Re: Objection to Proposed Lemanaghan Wind Farm, Co. Offaly 24/05/2026.
Case Reference Number: PAX19.324161
(www.lemanaghanwindfarmplanning.ie)

I wish to make a formal objection to the proposed Lemanaghan Wind Farm in Co. Offaly.

Figure 2 - Projected cause of Shadow Flicker

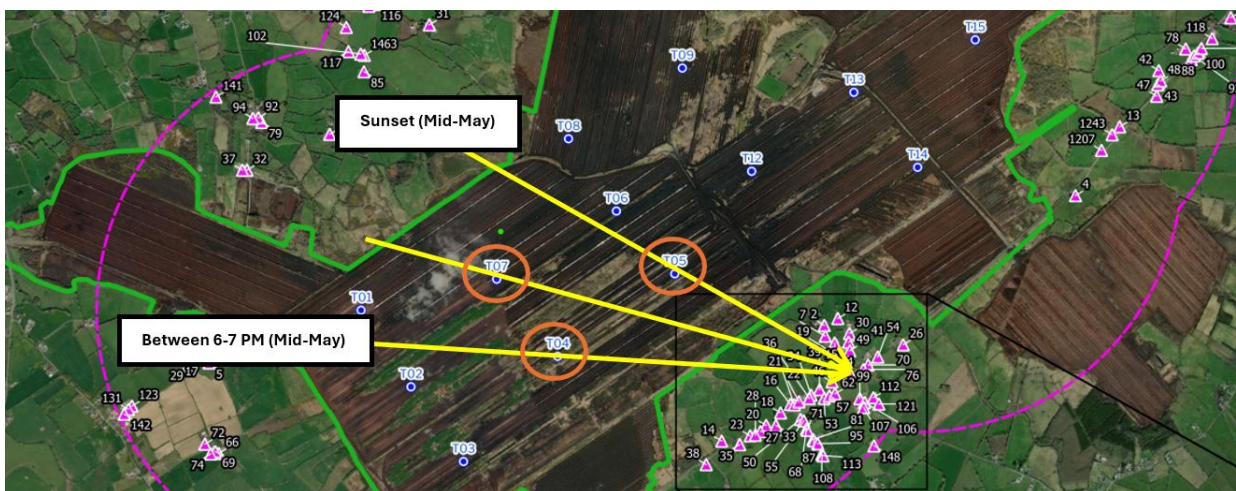
is fully estimation-based with no previous projects in Ireland for 220-meter turbines. The EIA admits in its own modelling that 128 sensitive receptors may experience some shadow flicker and that 58 sensitive receptors are predicted to exceed the 30 minutes/day guideline threshold before mitigation. Looking at the attached maps in Figure 1 and Figure 2, my fiancé's family home is within the shadow-flicker study area (Property 64 in [Chapter 5](#)), located approximately 1.1km from the closest turbine. The proposed placement of turbines would result in them experiencing shadow flicker due to turbine T05 at any time the sun is low in the sky in the run up to sunset. The following illustration from suncalc.org shows the current projected line of sunset for mid-May.

Overlaying this on the map indicating turbine positions, it's clear from Figure 2 that the marked location (Residence 64) is at high-risk of shadow flicker from turbine T05, but also T04 and T07. As the sun's position lowers along the horizon towards sunset.

Figure 3 - Turbine Proximity from Boher National School

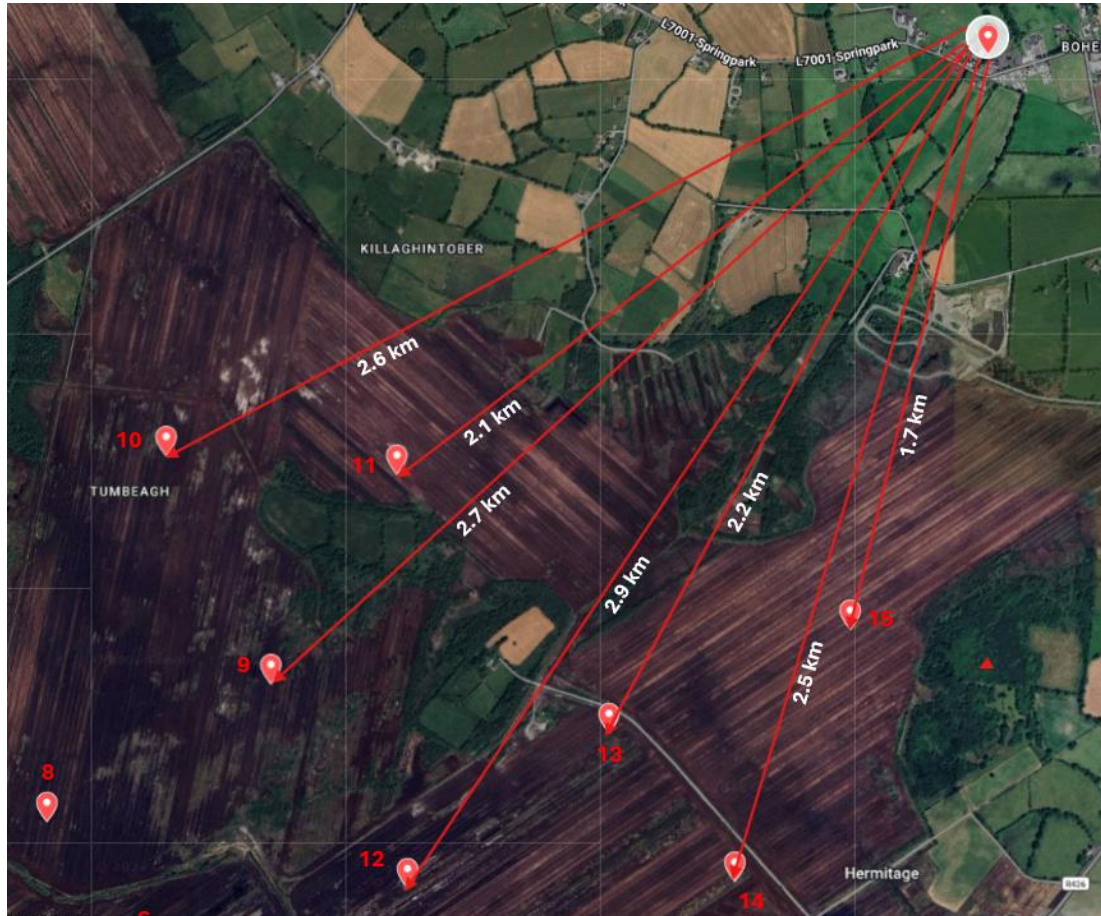
In [Chapter 12 - Noise and Vibration](#), the 30dB LA90 turbine noise contour extends to about 4.5km from each respective turbine. Looking at Figure 3 and Table 1, it is clear that the majority of the proposed turbines lie within 5km from Boher National School. Seven lie within 3km and T15 is just 1.7km away from the school. The key takeaway from this data though, is that 12 out of 15 turbines are within 4.5 km of Boher National

School. The EIAR clearly states in its turbine noise contour that the noise will extend 4.5km from each turbine. This alone is certainly grounds for a re-assessment of the potential effects on children attending the school's autism support facilities.

Figure 4 - Archaeological Sites in Lemanaghan (Appendix_13_7)

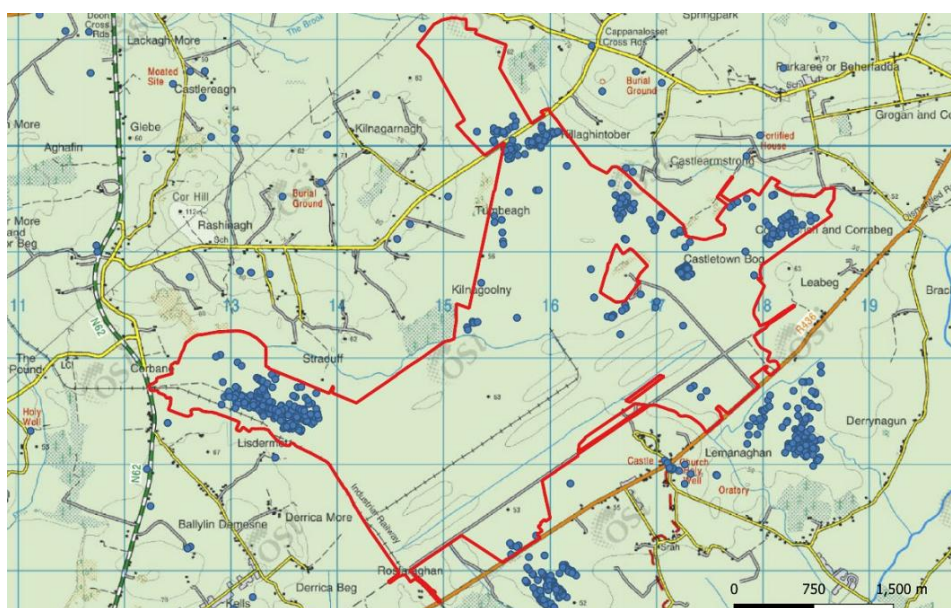
Figure 4 below illustrates the magnitude of archaeological sites that Lemanaghan and surrounding areas are home to - 470 known sightings of archaeological material in the Lemanaghan area. To assume that there is no likelihood of future archaeological investigations and progress with this proposed development would be detrimental to further discoveries.
